CITY PLAN COMMISSION

FILE NUMBER: Z212-218(JA) **DATE FILED:** March 15, 2022

REQUEST: An application for a Planned Development District for a public school other than an open enrollment charter school on property zoned an R-7.5(A) Single Family District.

STAFF RECOMMENDATION: **Approval**, subject to a revised development plan, a traffic management plan, a revised landscape plan, and staff's recommended conditions.

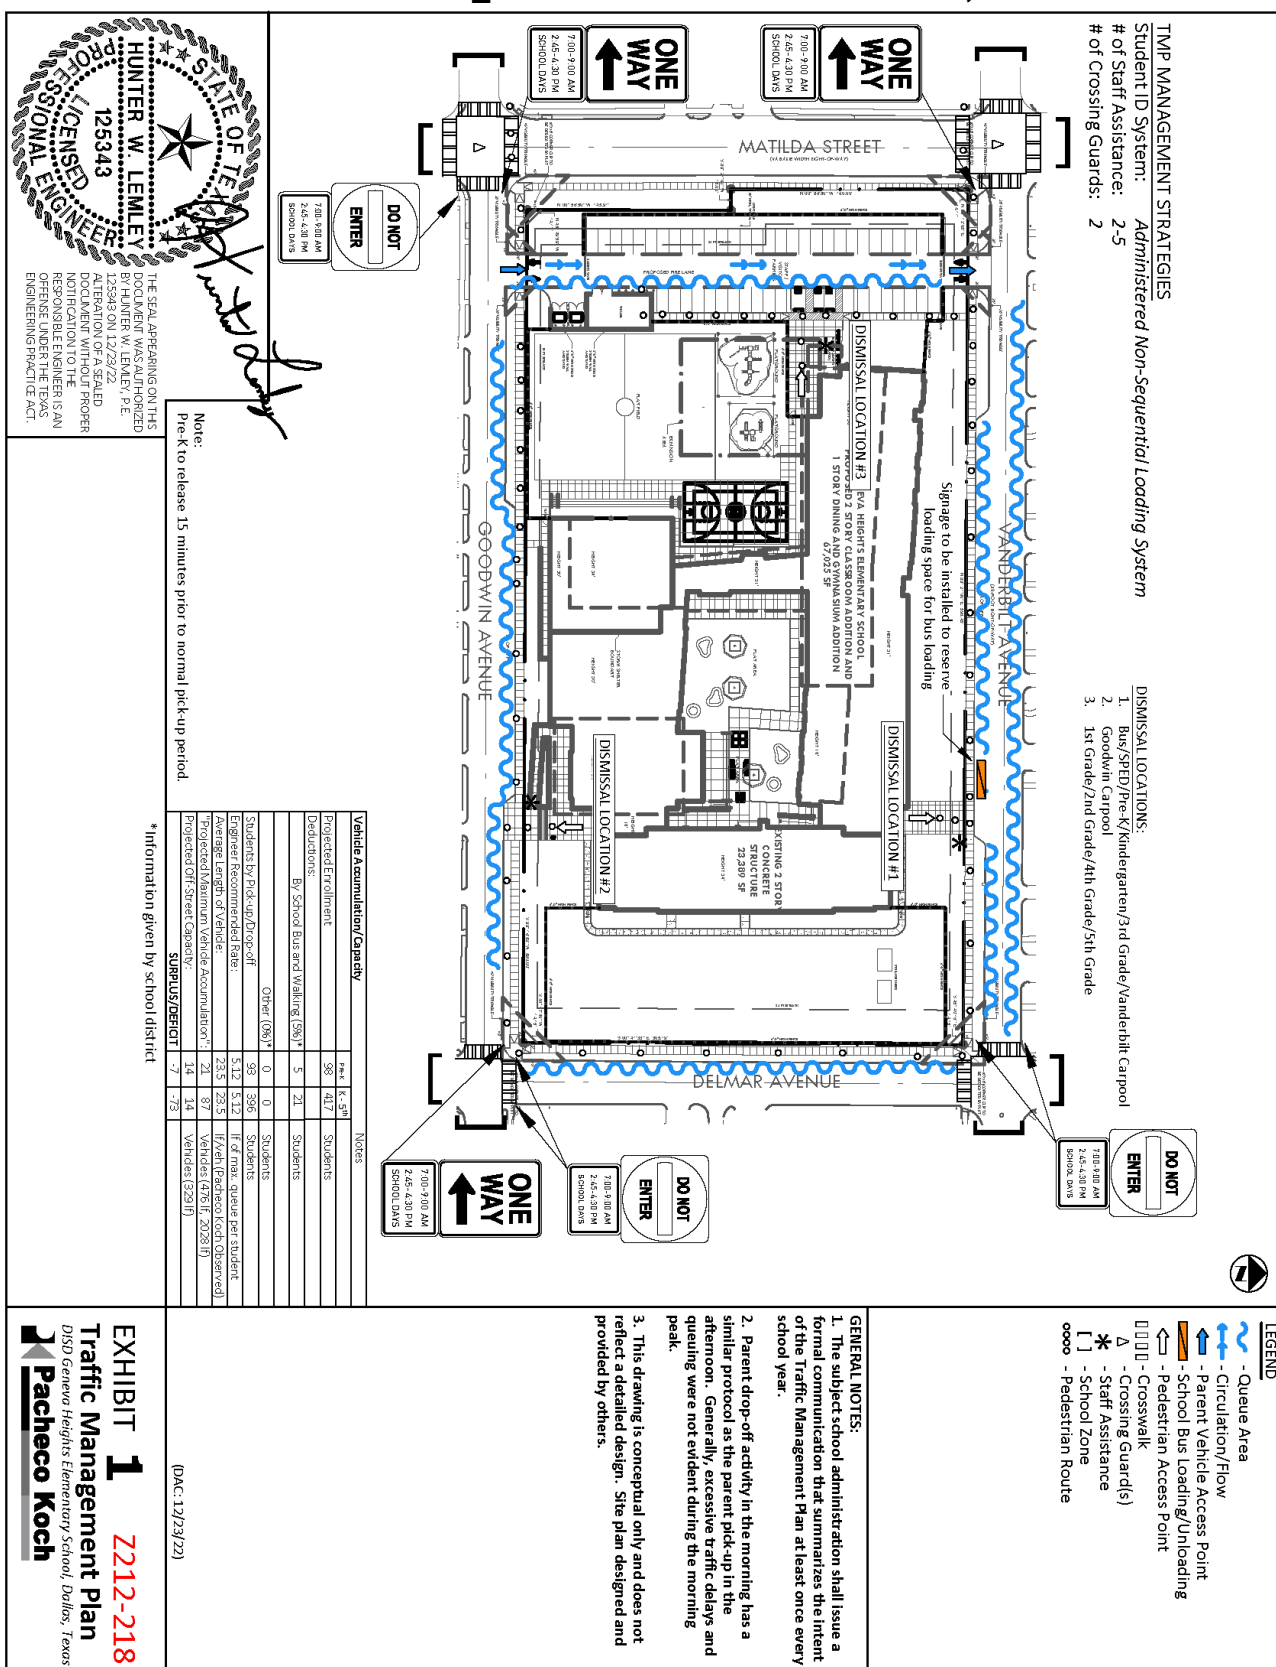
Staff comment:
TMP needs principal's signature.

PROPOSED EXHIBIT C_LANDSCAPE PLAN

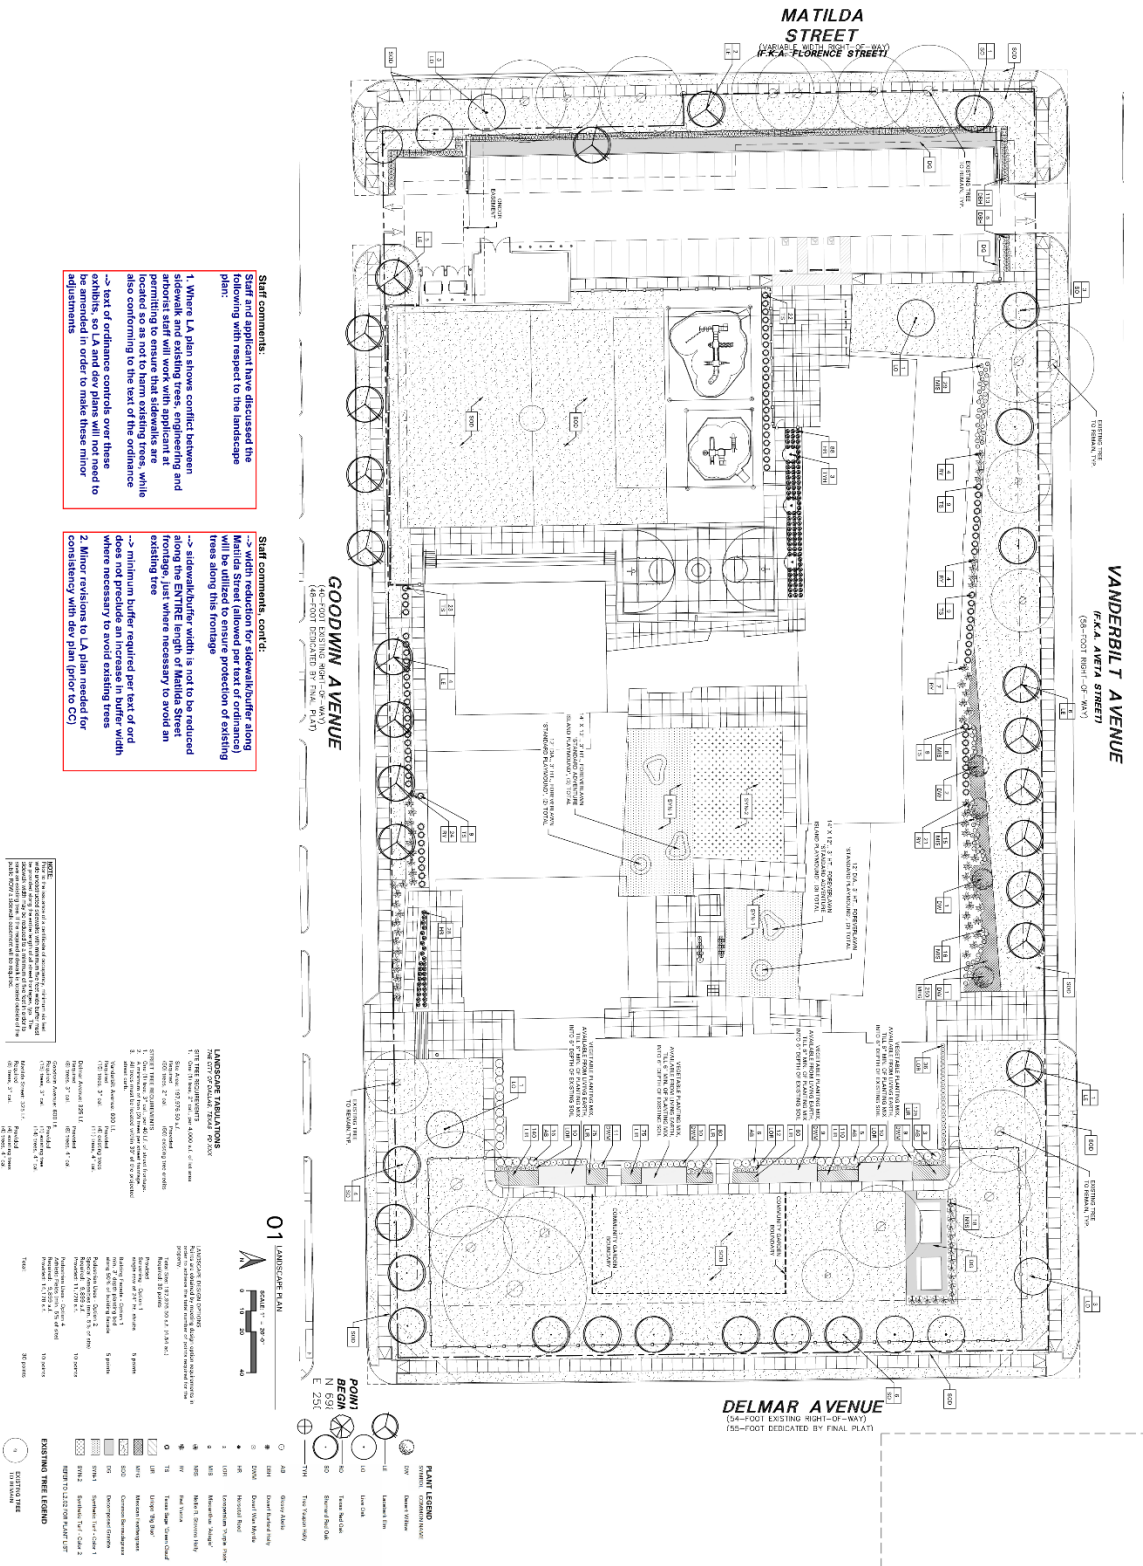
Except as noted in proposed Sec. 51P-xxx.111, landscaping must be provided in accordance with Article X of the Dallas Development Code. As a condition of the PD, a landscape plan that complies with Article X must be approved by the city plan commission prior to submitting for a building permit. Proposed Exhibit C_Landscape Plan is included in the docket and is recommended for approval by the city arborist, subject to staff comments noted on the proposed landscape plan shown later in this staff report.
